Well Name: BLUITT 13 A FEDERAL	Well Location: T8S / R37E / SEC 13 / NESW /	County or Parish/State: ROOSEVELT / NM
Well Number: 11	Type of Well: CONVENTIONAL GAS WELL	Allottee or Tribe Name:
Lease Number: NMNM044216	Unit or CA Name:	Unit or CA Number:
US Well Number: 3004120174	Well Status: Producing Gas Well	Operator: OXY USA INCORPORATED

Type of Action: Plug and Abandonment

**Bluitt 13 A Federal 11
30-041-20174
Oxy USA Incorporated
July 20, 2021
Conditions of Approval**

OXY USA Inc. - Proposed
Bluitt 13 A Federal #11
API No. 30-041-20174

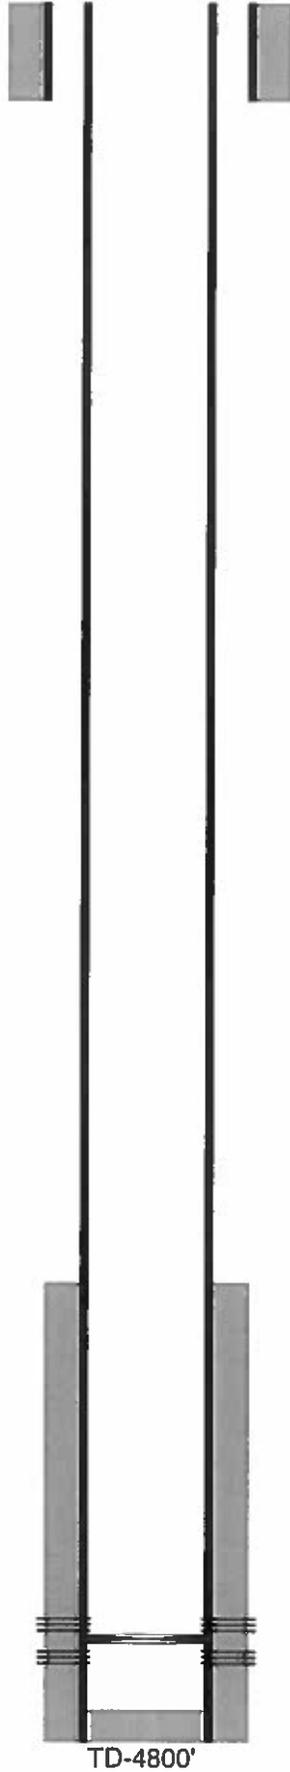
- 1. Operator shall place CIBP at 4,454' (50'-100' above top most perf) and place 65 sx of Class C cement on top as proposed. WOC and TAG.**
- 2. Operator shall perf and squeeze at 2,685'. Operator shall place a balanced Class C cement plug from 2,685'-2,555' to seal the top of the Yates formation. WOC and TAG.**
- 3. Operator shall perf and squeeze at 2,451'. Operator shall place a balanced Class C cement plug from 2,451'-2,321' to seal the top of the Salt formation.**
- 4. Operator shall perf and squeeze at 354'. Operator shall place a balanced Class C cement plug from 354'-surface as proposed to seal the 8-5/8'' shoe as proposed.**
- 5. See Attached for general plugging stipulations.**

OXY USA Inc. - Proposed
Bluitt 13 A Federal #11
API No. 30-041-20174

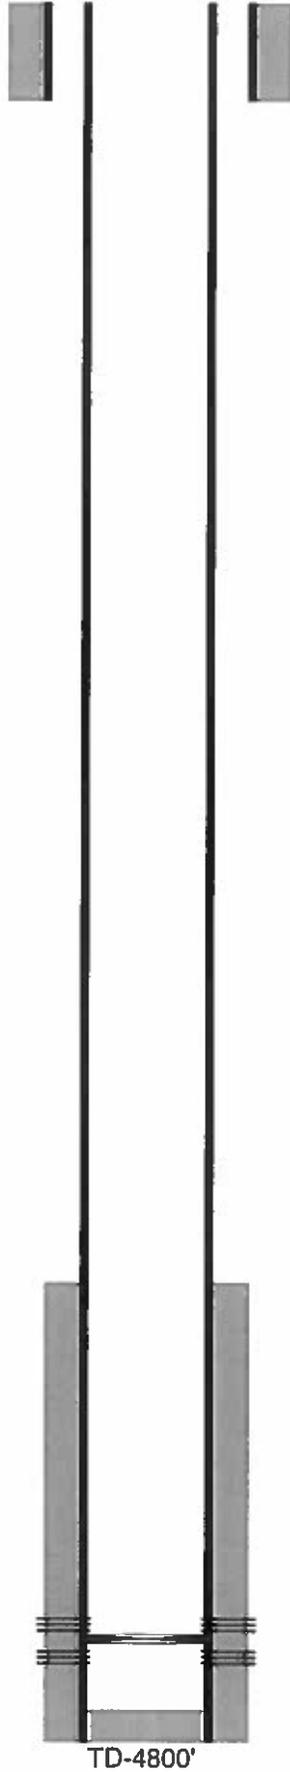
- 1. Operator shall place CIBP at 4,454' (50'-100' above top most perf) and place 65 sx of Class C cement on top as proposed. WOC and TAG.**
- 2. Operator shall perf and squeeze at 2,685'. Operator shall place a balanced Class C cement plug from 2,685'-2,555' to seal the top of the Yates formation. WOC and TAG.**
- 3. Operator shall perf and squeeze at 2,451'. Operator shall place a balanced Class C cement plug from 2,451'-2,321' to seal the top of the Salt formation.**
- 4. Operator shall perf and squeeze at 354'. Operator shall place a balanced Class C cement plug from 354'-surface as proposed to seal the 8-5/8'' shoe as proposed.**
- 5. See Attached for general plugging stipulations.**
